Subject: **San Onofre Nuclear Generating Station Units 2 and 3**
Docket Nos. 50-361 and 50-362
Proposed Change Number NPF-10/15-551
License Amendment Request, "Reactor Coolant System (RCS) Pressure and Temperature Limits Report (PTLR)"

DESCRIPTION AND NO SIGNIFICANT HAZARDS ANALYSIS FOR PROPOSED CHANGE NPF-10/15-551 RELOCATION OF REACTOR COOLANT SYSTEM (RCS) PRESSURE AND TEMPERATURE CURVES FROM THE TECHNICAL SPECIFICATIONS TO A PRESSURE AND TEMPERATURE LIMITS REPORT (PTLR) San Onofre Nuclear Generating Station Units 2 and 3

~~Figure 3.4.3-1~~

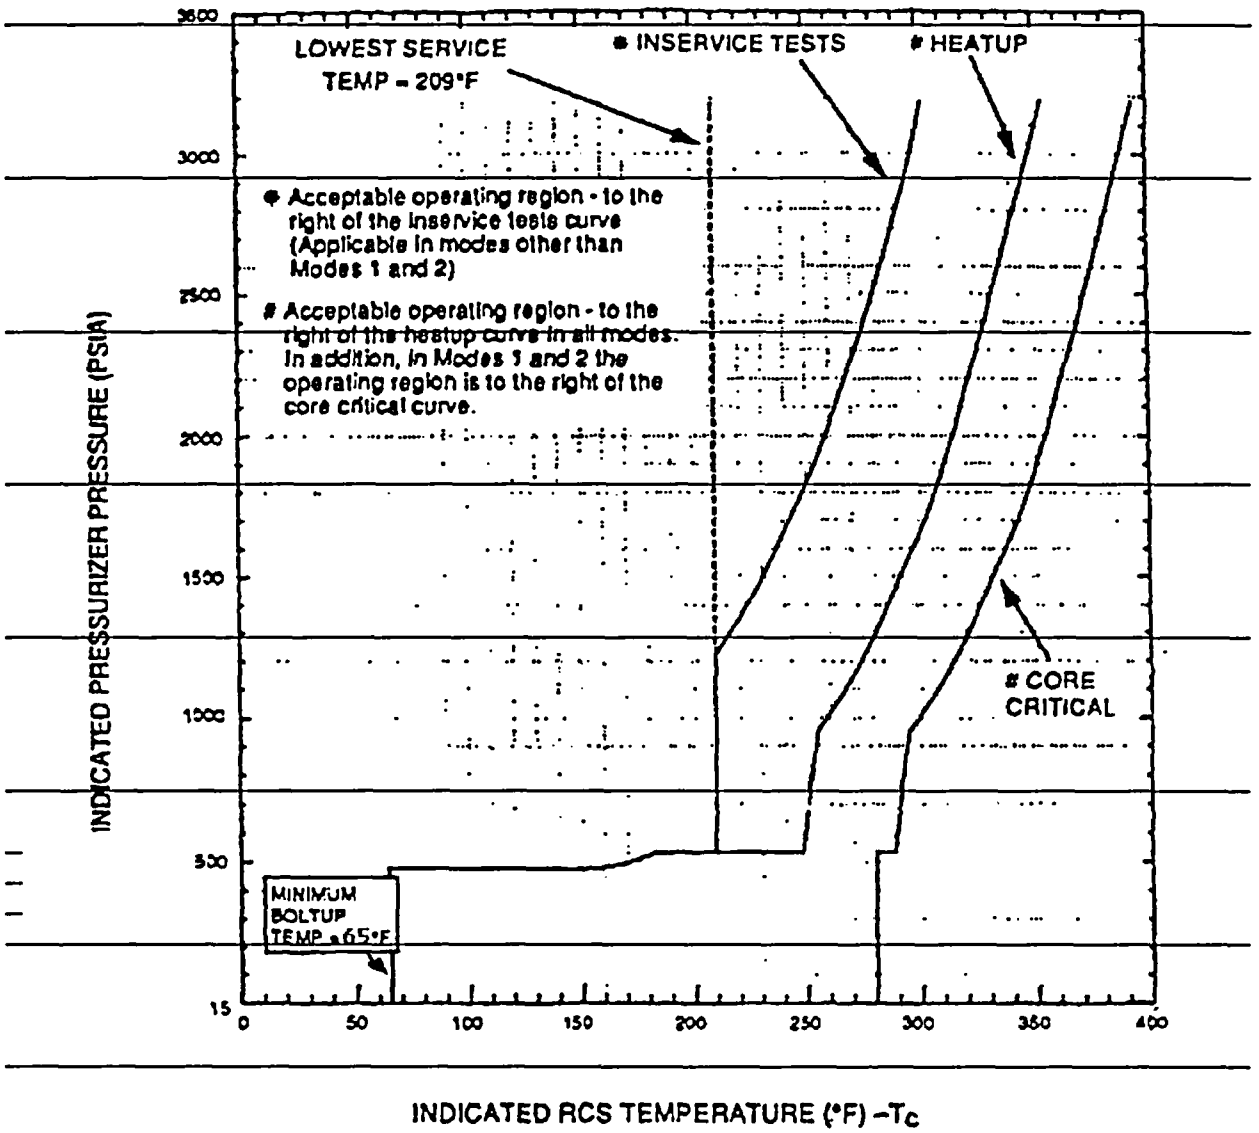
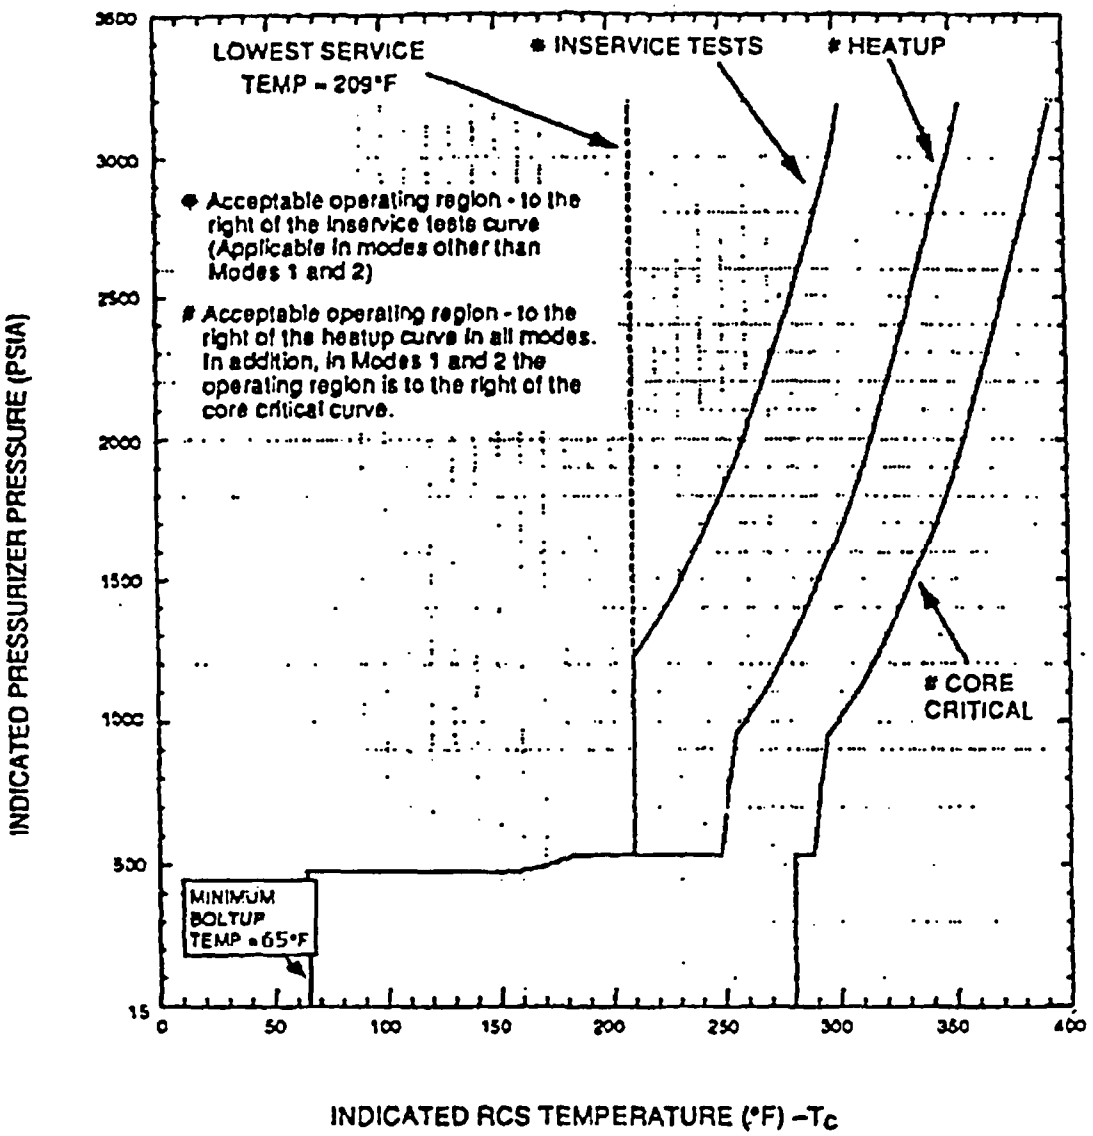
LCO 3.4.12.1 No more than two high pressure safety injection pumps shall be OPERABLE, the safety injection tanks shall be isolated or depressurized to less than the limit specified in the PTLR~~Figure 3.4.3-2~~ and at least one of the following overpressure protection systems shall be OPERABLE:

SIT isolation or depressurization to less than the ~~Figure 3.4.3-2 limit~~limits in the PTLR is only required when SIT pressure is greater than or equal to the maximum RCS pressure for the existing RCS cold leg temperature allowed by the PTLR~~P/T limit curves provided in Figure 3.4.3-1 and Figure 3.4.3-2~~.

Figure 3.4.3-1
DELETED

~~FIGURE 3.4.3-2~~

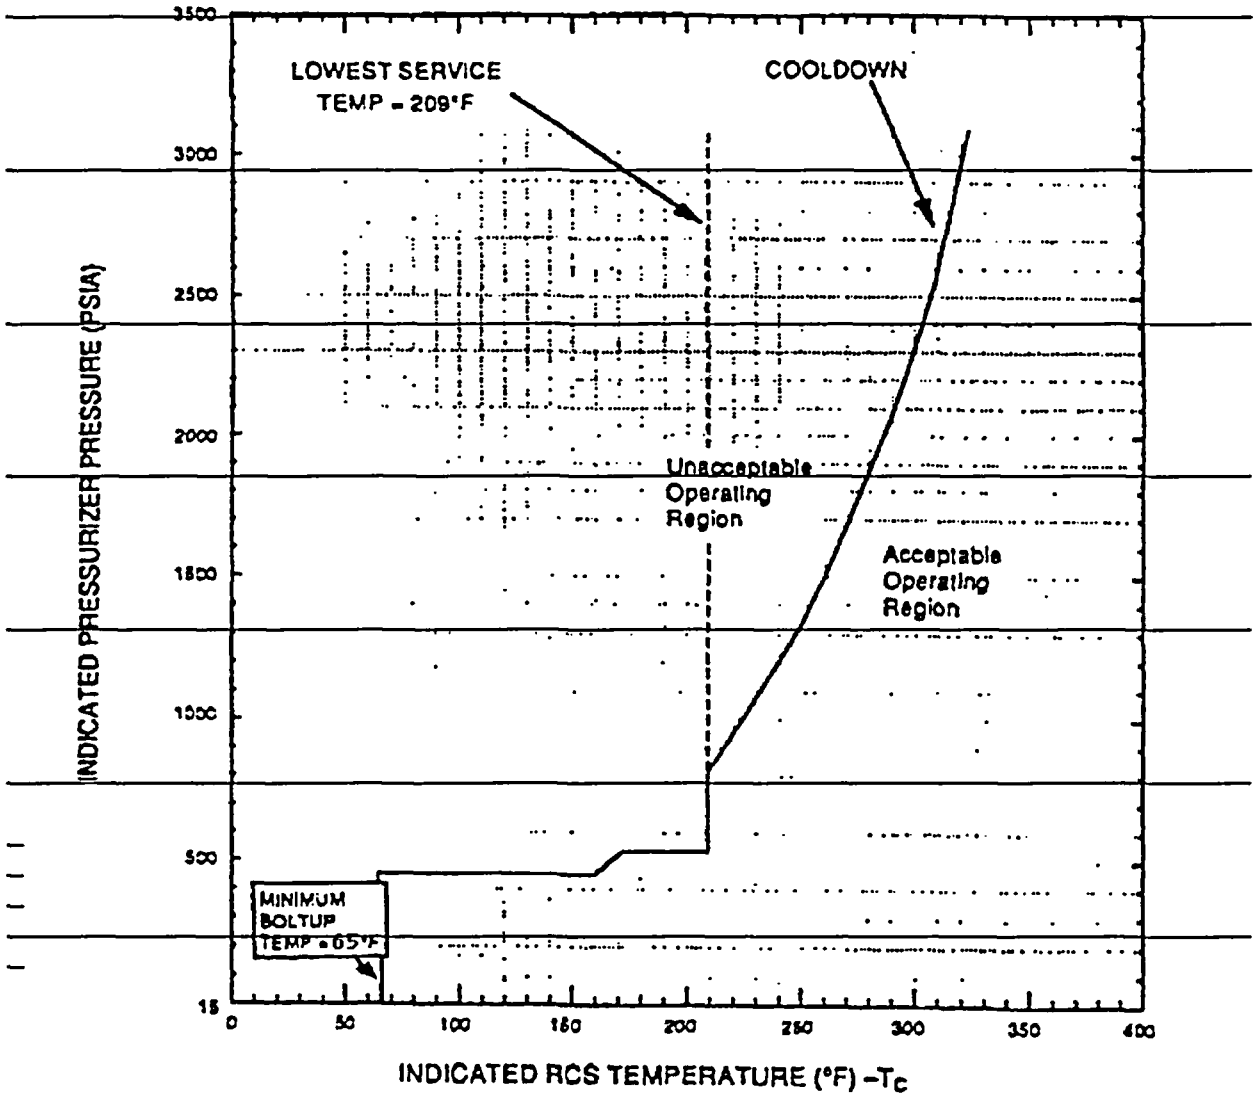
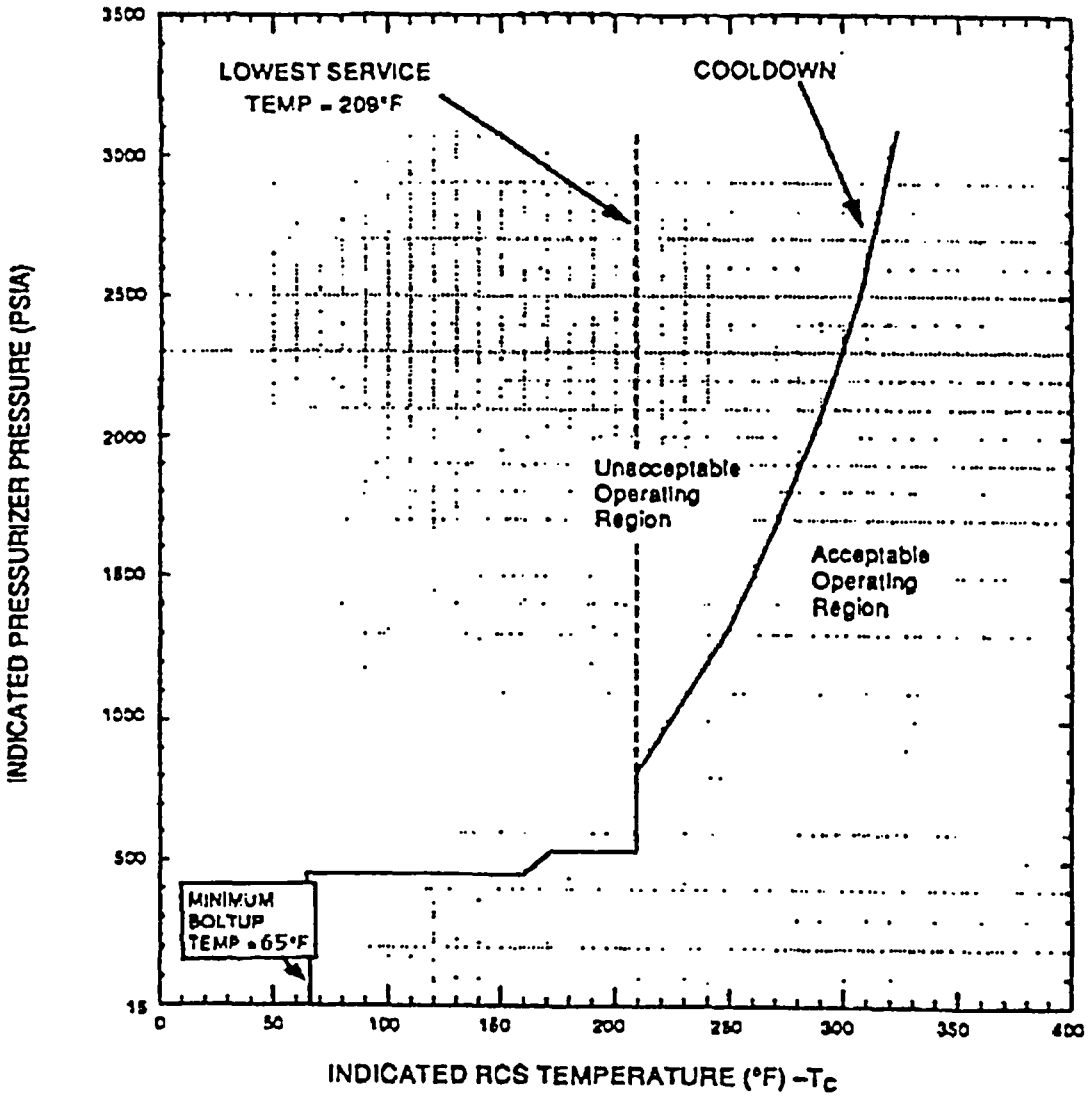
FIGURE 3.4.3-2
DELETED

~~FIGURE 3.4.3-3~~

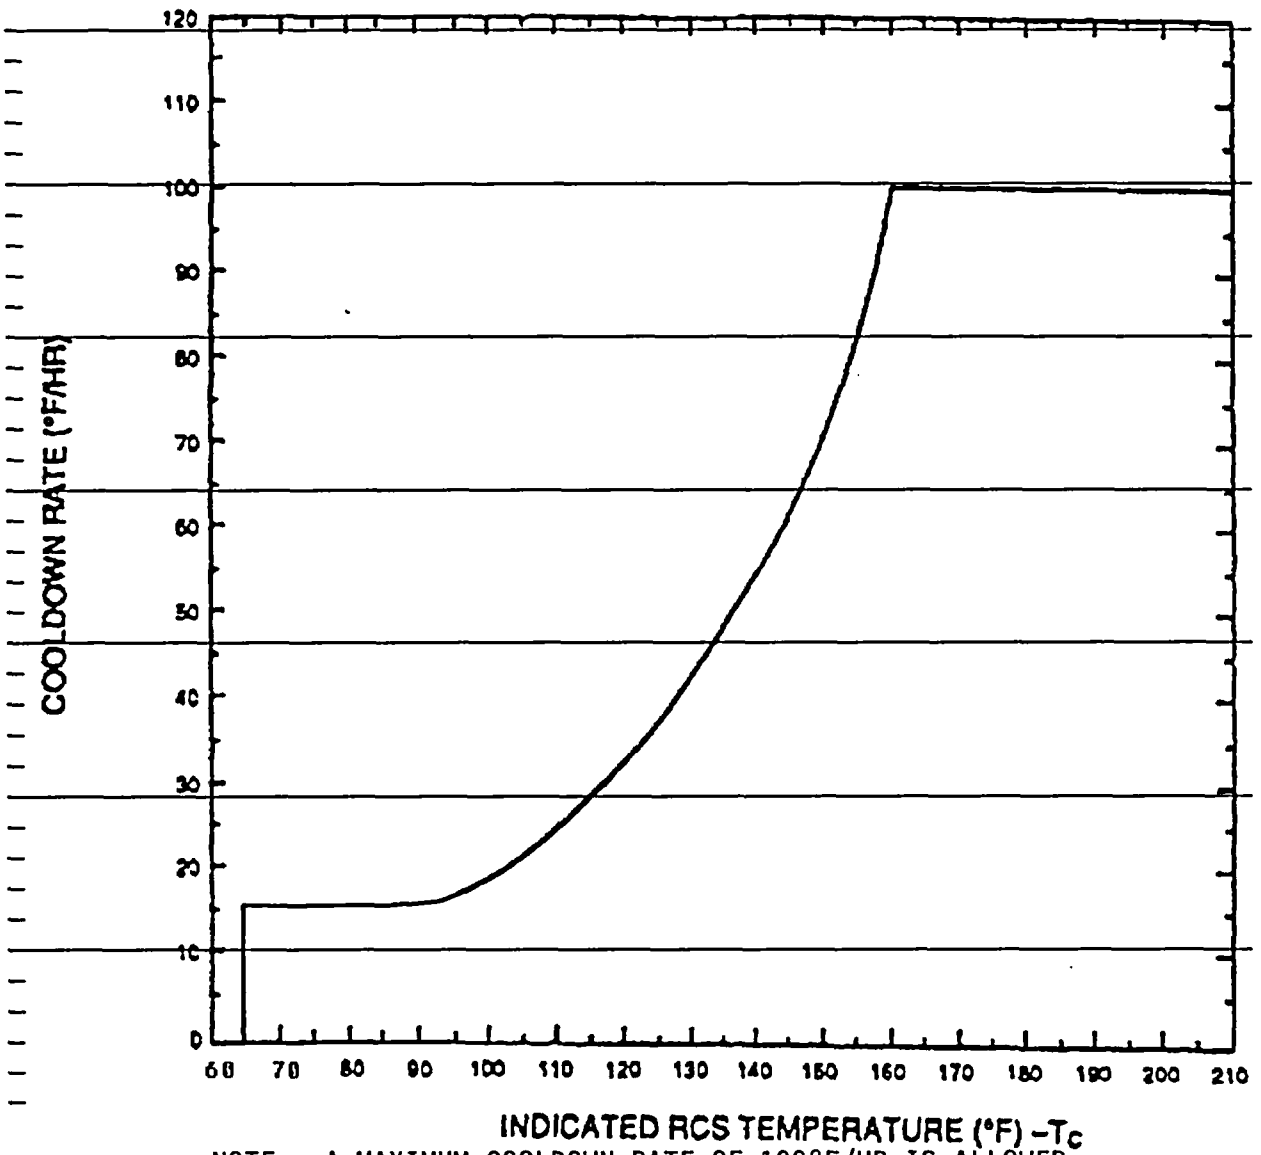
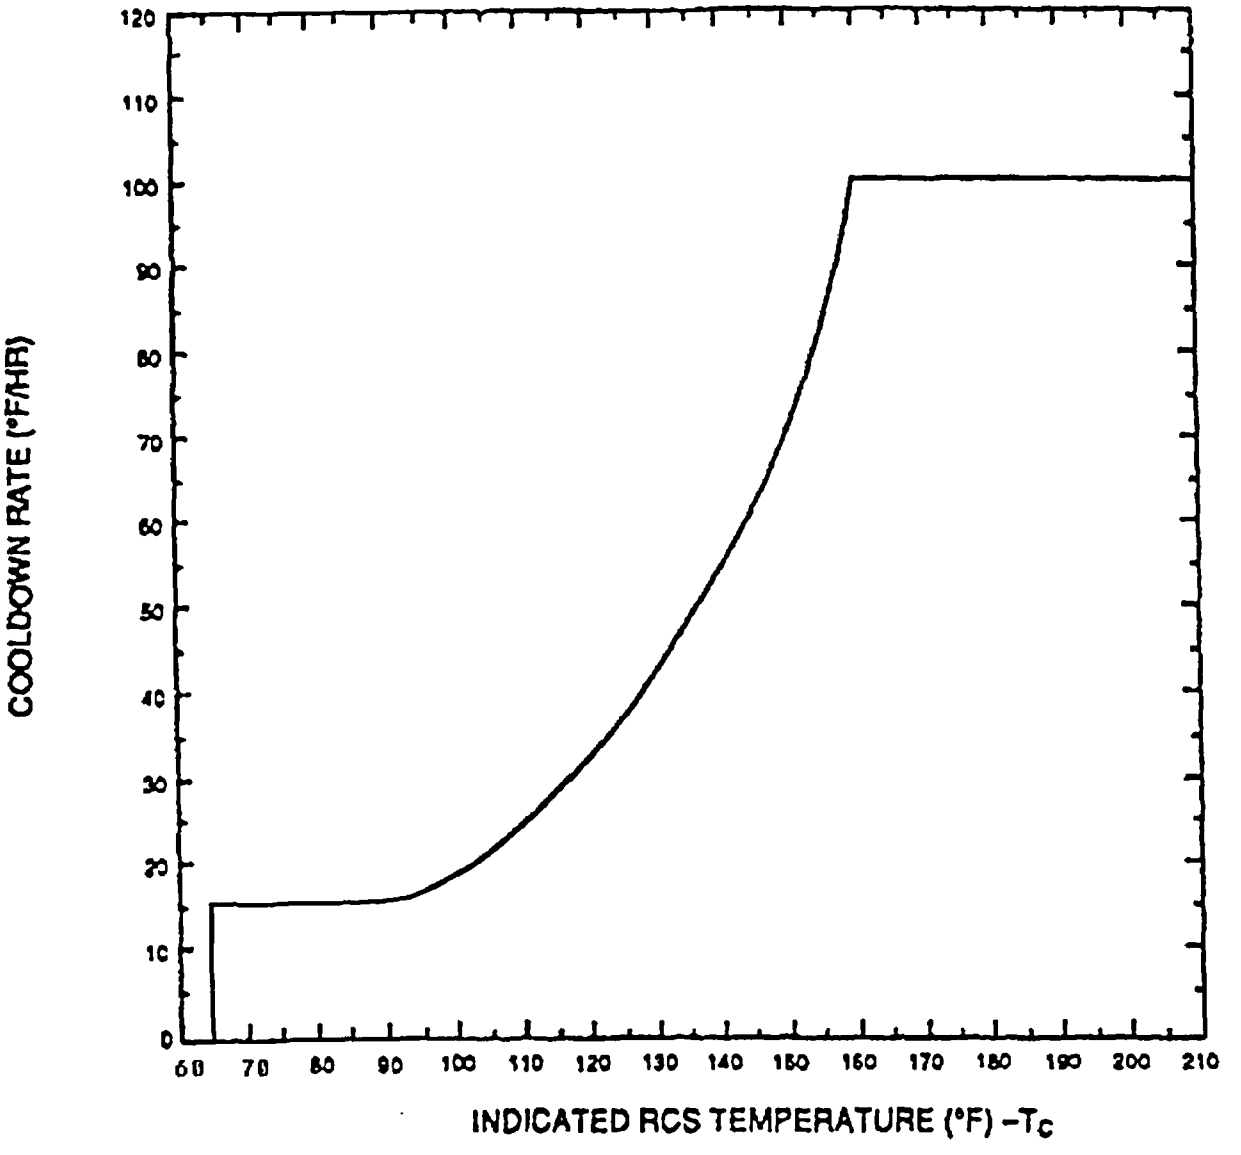
~~b. A maximum cooldown as specified by Figure 3.4.3-3 in any 1-hour period with RCS cold leg temperature less than or equal to 160°F. A maximum cooldown of 100°F in any 1-hour period with RCS cold leg temperature greater than 160°F.~~

FIGURE 3.4.3-3
DELETED

~~FIGURE 3.4.3-4~~

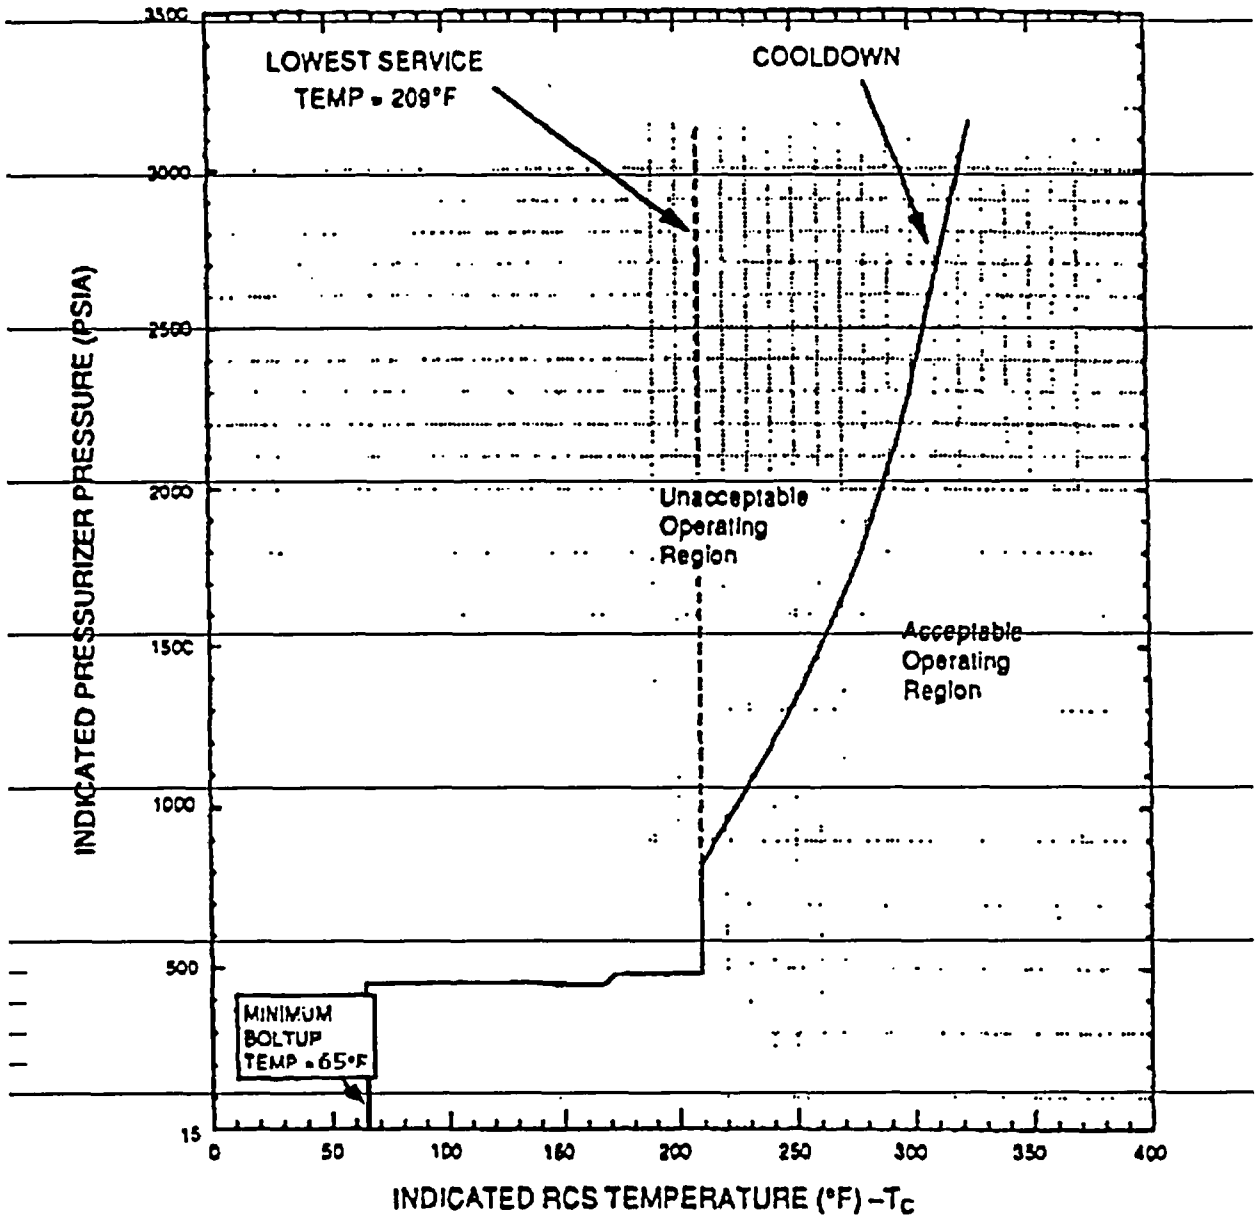
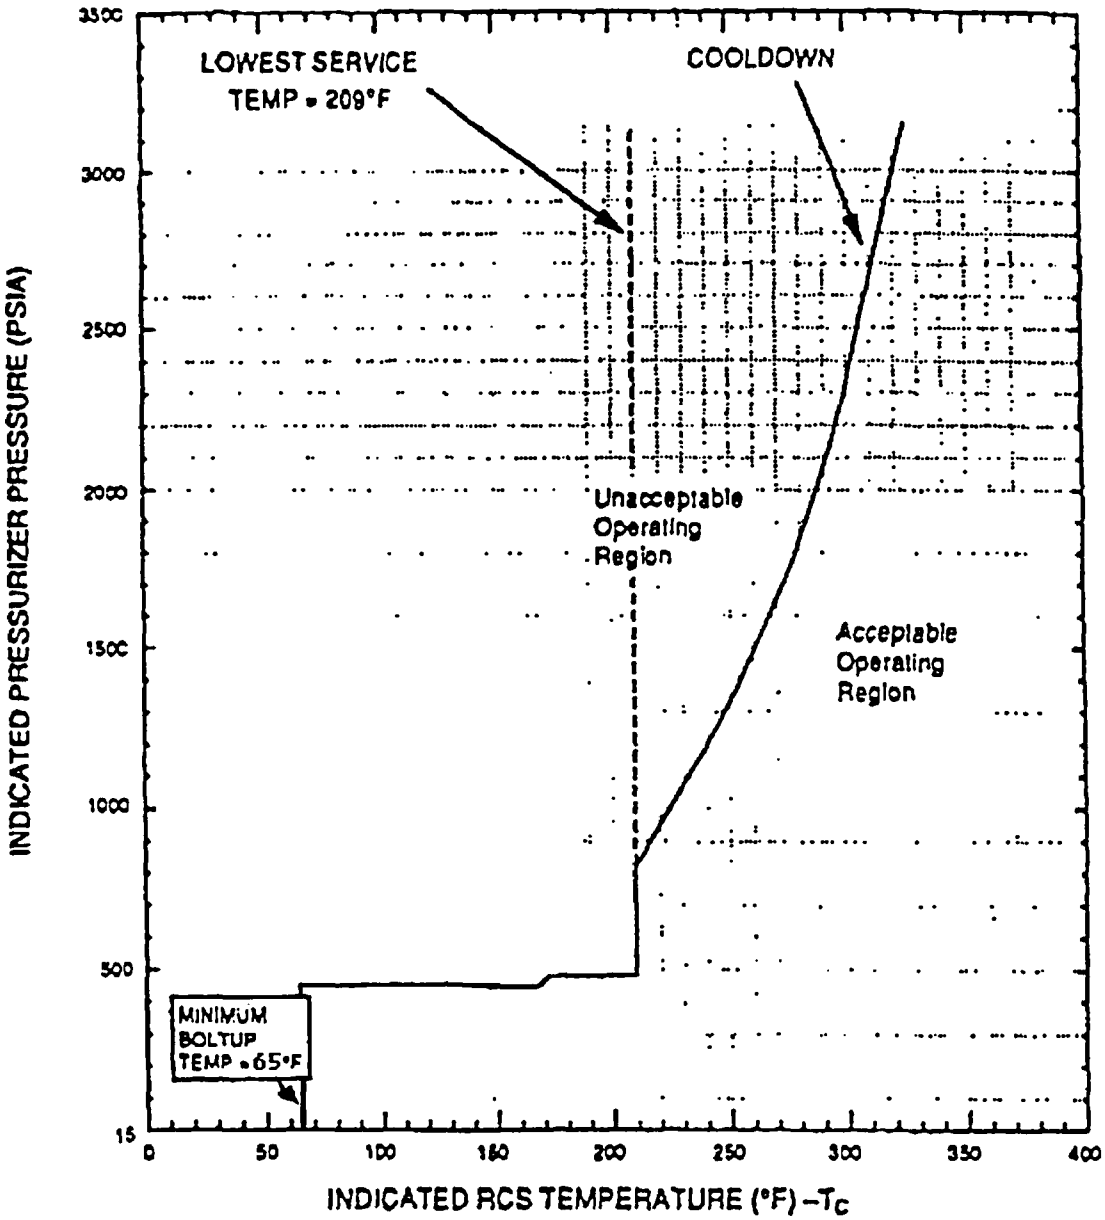
FIGURE 3.4.3-4
DELETED
